**RE: DA 22/11144 - 60-64 SHOWGROUND ROAD GOSFORD –
PROPOSED INTEGRATED HEALTH HUB FACILITY AND
DISABILITY ACCOMMODATION – SECTION 4.55 (2)
MODIFICATION APPLICATION**

60-64 Showground Road Gosford Section 4.55(2) Modification

Figure 1 – Approved building height

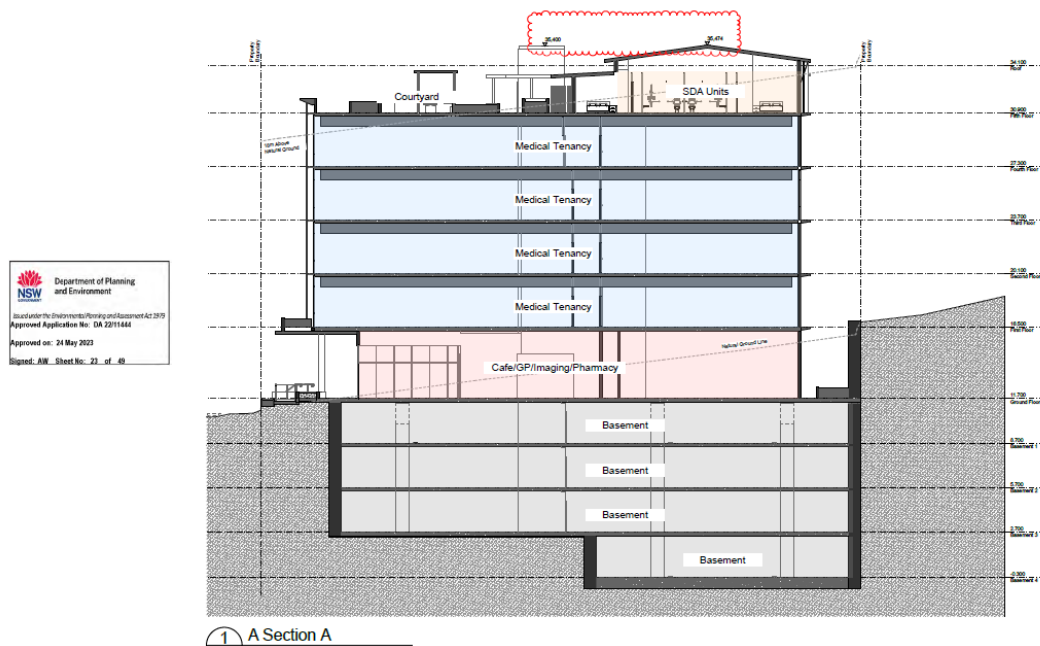
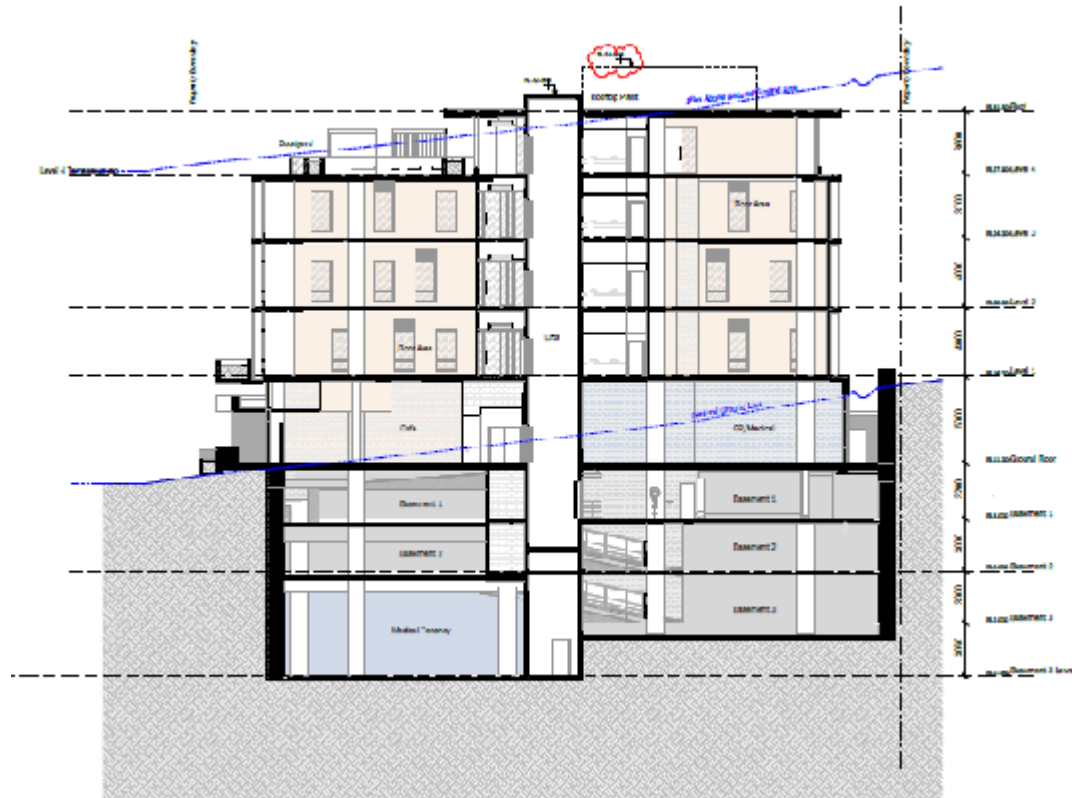
The approved development has a maximum height of RL 35.474 (top of roof pitch of SDA Units) with lift overrun RL 35.400 – refer **Figure 1** below. The approved development exceeded the 18m height limit by a maximum of 4.1m on southern side.

Excluding roof top plant (RL 34.050), the amended development has a maximum height of RL31.500 (top of medical tenancies) with lift overrun being RL 32.380. The lift overrun has a small area and is located in the centre of the building - refer **Figure 2** below and amended drawing set prepared by TVS Architects at **Attachment 1**. At the fourth floor, the medical tenancies will be located on the western side of the building in the area previously occupied by the SDA, with the landscaped courtyard on the eastern side to remain.

The overall reduction in building height will reduce the visual bulk of the building and associated overshadowing impacts on adjoining properties.
